## ADT SUPPLEMENT FOR VOICE ALARM SYSTEM

(MANUAL #A15890 Rev. A)

Document 50329 Rev A 6/27/95 ECN 95-305

Figure 6-2: AA-30 Terminals and Connectors

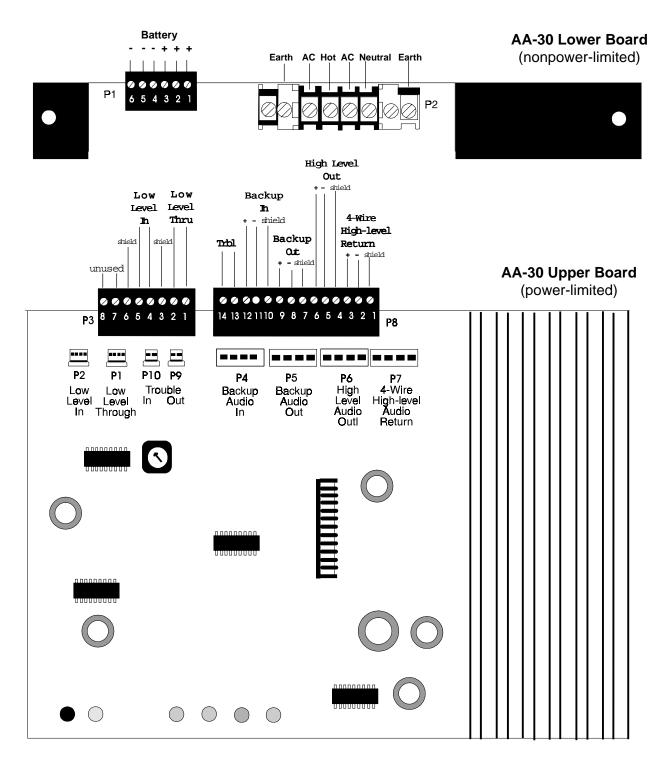
Replace page 30 with the following information which references power-limited and nonpower-limited circuits.

**Note:** The low-level input and high-level output "P" connectors are primarily for in-cabinet applications where the wiring to or from the AA-30 remains in the cabinet. For "multiple-cabinet" applications, hard-wire the system using the terminal blocks P3 and P8.

Figure 6-5: AA-100/AA-120 Terminals and Connectors

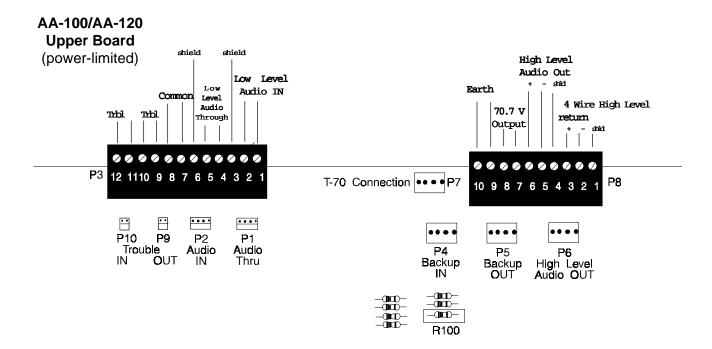
Replace page 33 with the following information which references power-limited and nonpower-limited circuits.

**Note:** The low-level input and high-level output connectors are primarily for in-cabinet applications where the wiring to or from the AA-100/AA-120 remains in the cabinet. For "multiple-cabinet" applications, use the terminals.
